Further to my oral submission at the Public Hearing, I wanted to express my concerns over topics that weren't covered due to time constraints.

## Site Servicing

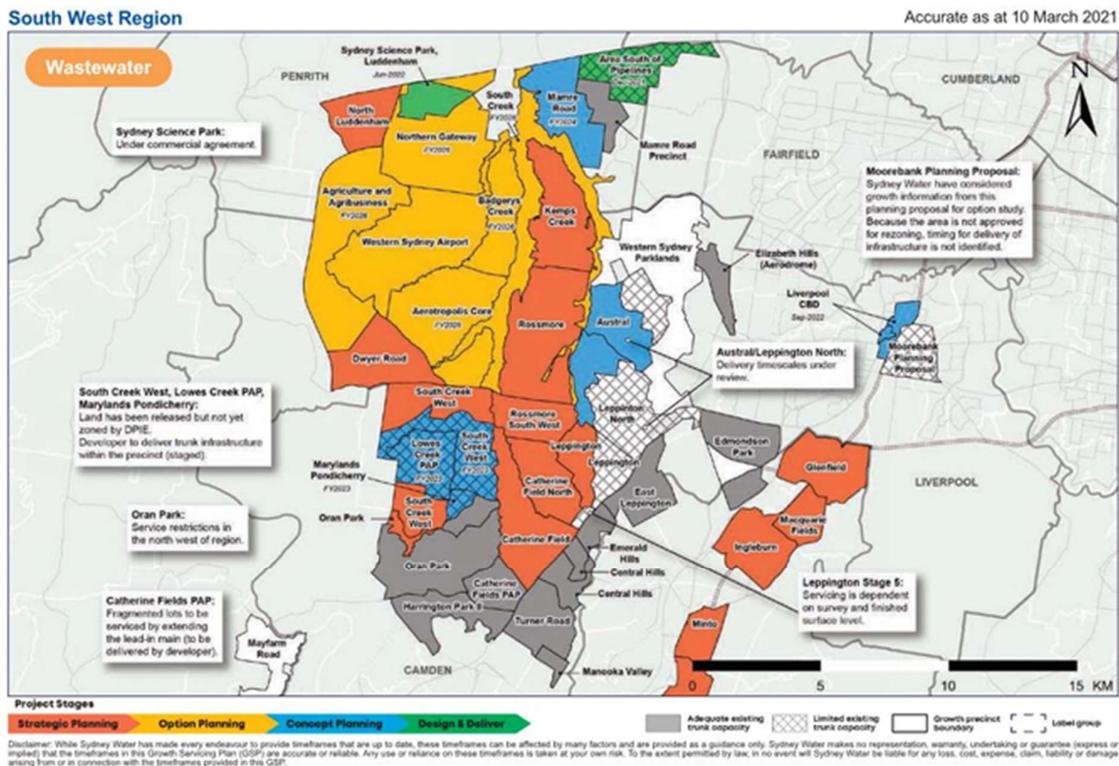
Sydney Water advised that full water servicing for the proposed development is feasible following 2030 Leppington trunk infrastructure upgrades. Until then, **the proposed temporary break water tank can only be filled using Sydney Water supply between 9pm to 5am.**

Sydney Water mandates that such tanks only refill during off-peak hours (9 pm to 5 am) to protect the upstream network, confirming the tank's role as a temporary buffer during high-demand daylight hours rather than a long-term storage solution.

A 35 kL (35,000 litre) break tank serving 1,000 people will last between **1.5 and 4 hours** based on average Sydney water usage rates, assuming no water is flowing into the tank during that time.
